Fargo VAMC – Refurbish Elevators and Replace Controls

Fargo, North Dakota
Project #19-2481

MARCH 26, 2024

ADDENDUM NO. 2

1 ELEVATION - LIBERTY 1,2,3 - TYPICAL
1/2" = 1'-0"

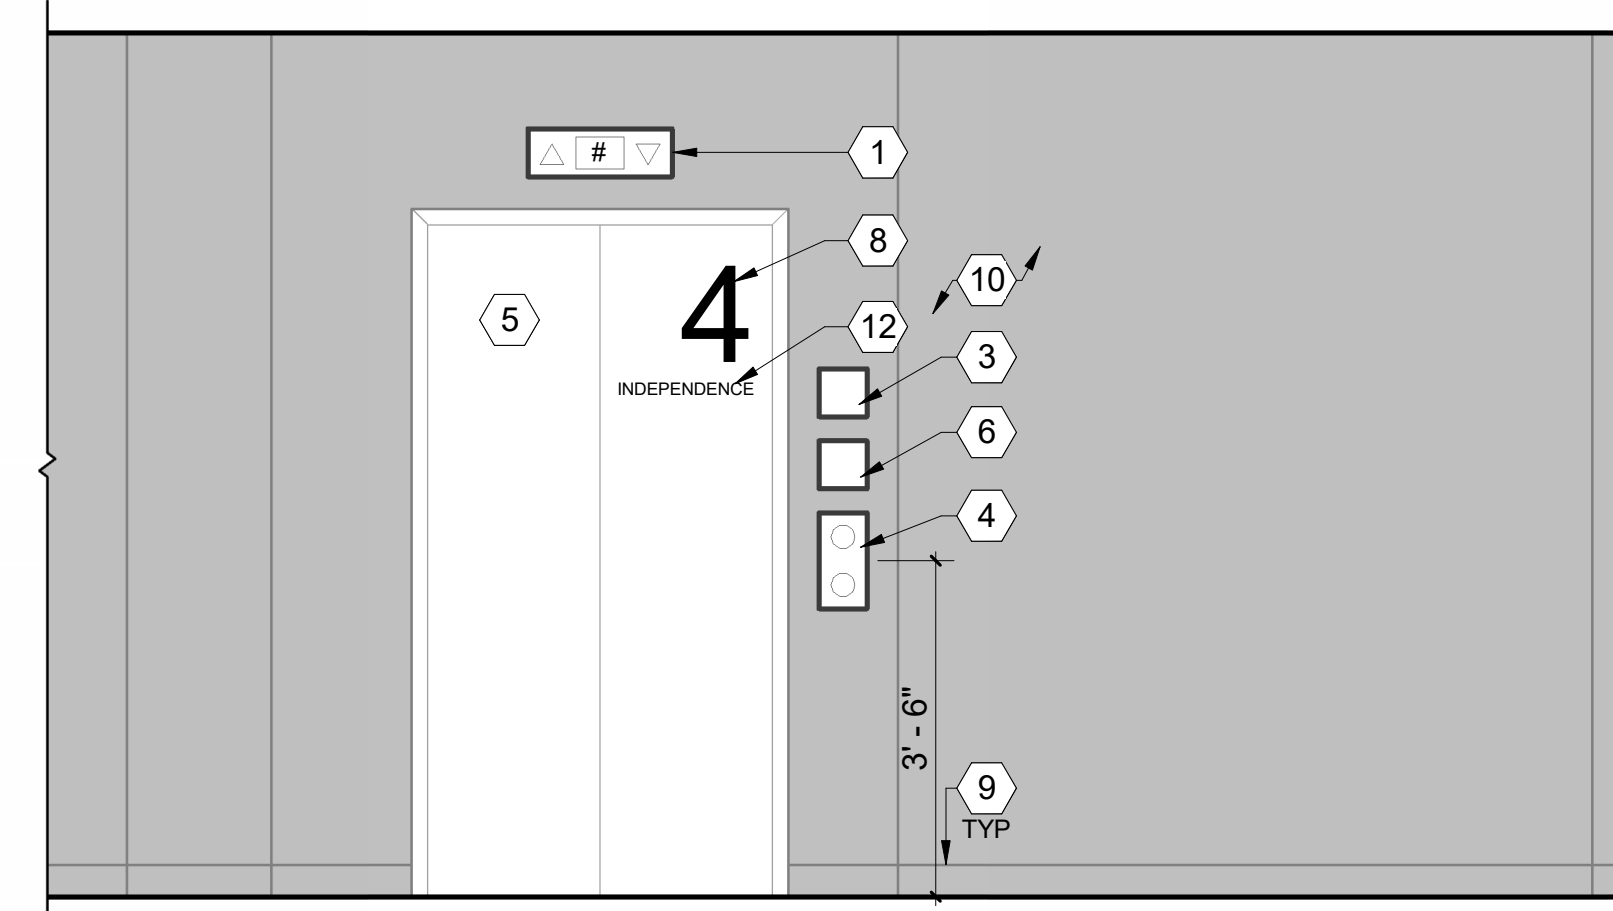
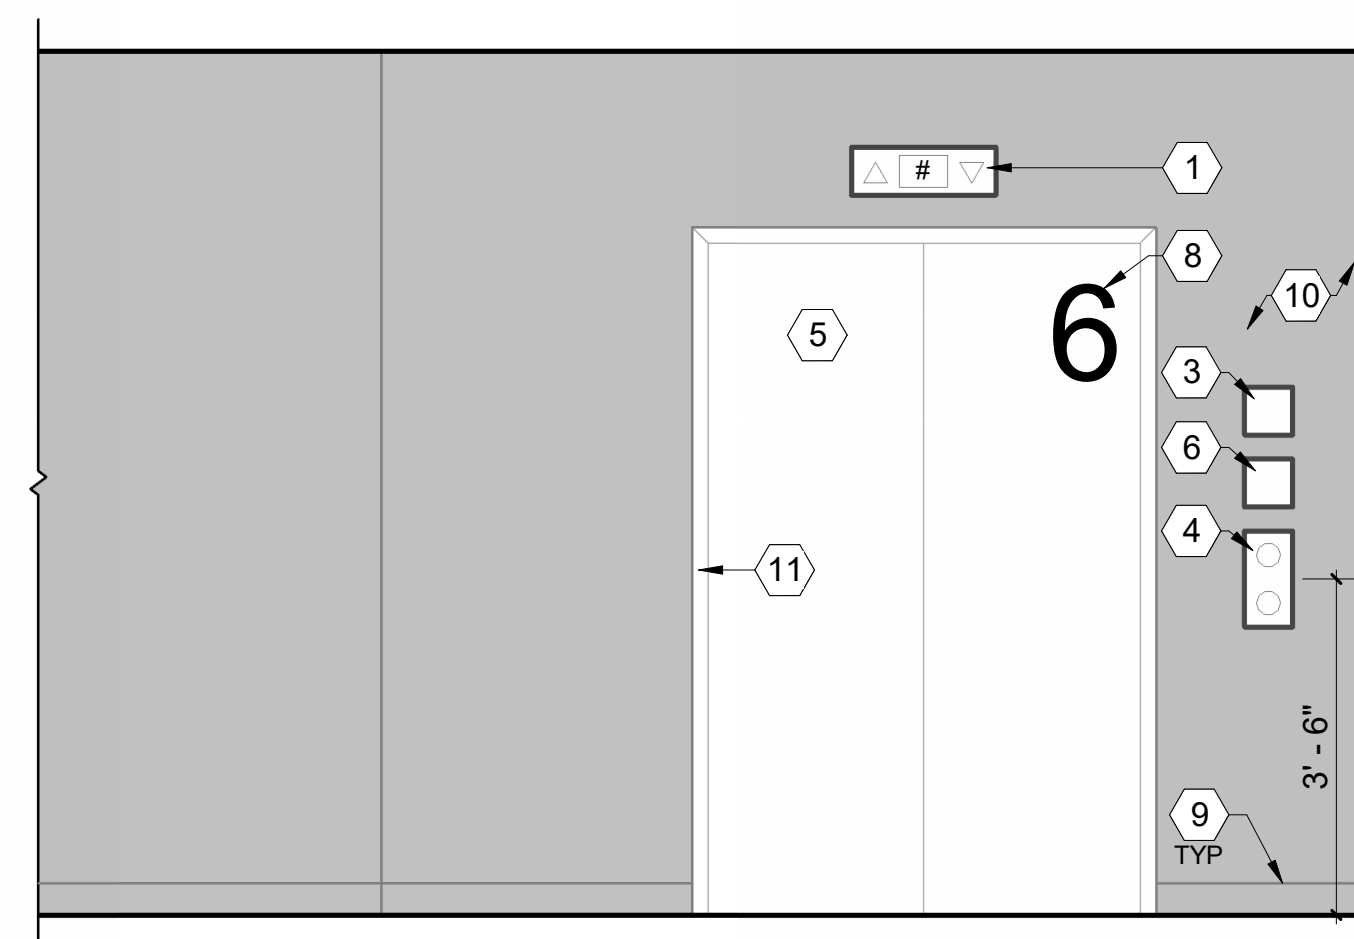
Drawing Sheet A5.30 INTERIOR ELEVATIONS - LOBBIES – See revised drawing sheet for the adjustment of keynotes # 11.

9. EXISTING WALL BASE TO REMAIN, TYPICAL.
10. PATCH, REPAIR AND FINISH ALL EXISTING WALLS AS REQUIRED FOR REPLACEMENT OF ALL CONTROLS AND INDICATORS.
11. RECLAD EXISTING STAINLESS STEEL HOISTWAY ENTRANCE JAMBS.
